SERVICE LETTER

SERVICE LETTER No. 089

Wastegate Expander Ring

Figure 1 - Outside Diameter Lower than Inside Diameter.

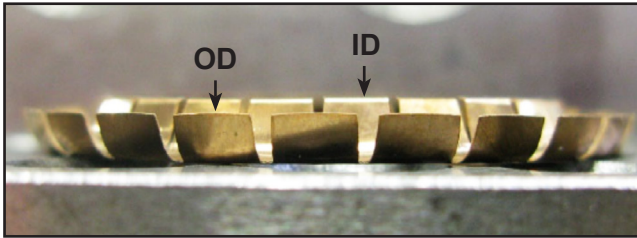
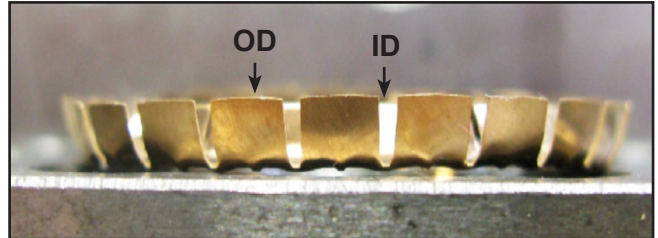
- (a) Some degree of part-to-part shape variation may be noted for wastegate expander-ring P/N 476762-0000. Figures 1 thru 3 depict the variation that may be observed. Conditions depicted are acceptable for use.

NOTE: All configurations above are acceptable and may be used in affected wastegate assemblies.
